TRANE[®]

General Service Bulletin

Thrust Bearing Design Change

Figure 1. Center feed thrust bearing installed

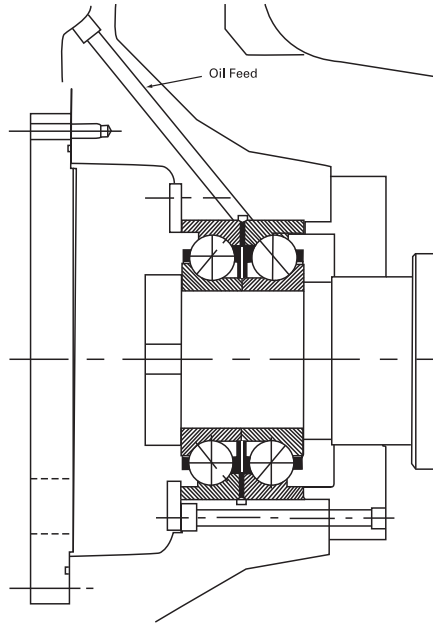
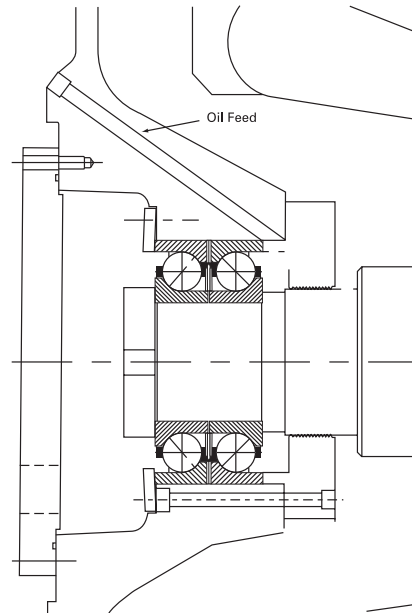
This new design utilizes a center oil feed (see [Figure 1, p. 2](#)) instead of the axial oil feed used previously (see [Figure 2, p. 2](#)). These new bearings have shallow grooves machined in the face of the outer races on the back side of each bearing (see [Figure 3, p. 3, Detail A](#)). When mounted on the compressor shaft in a back to back arrangement, these grooves allow oil to be fed to the center of the duplex bearing set. No other change to the bearing is incorporated.

If the new center feed bearing bracket is installed (starting with the design sequence specified in [“Units Affected,” p. 3](#)) on the machine, the new center feed thrust bearings **must be used** or catastrophic thrust bearing failure will occur due to lack of lubrication. For non-K4 shaft compressors, it is imperative to use the undersized bore bearings to allow proper interference fit.
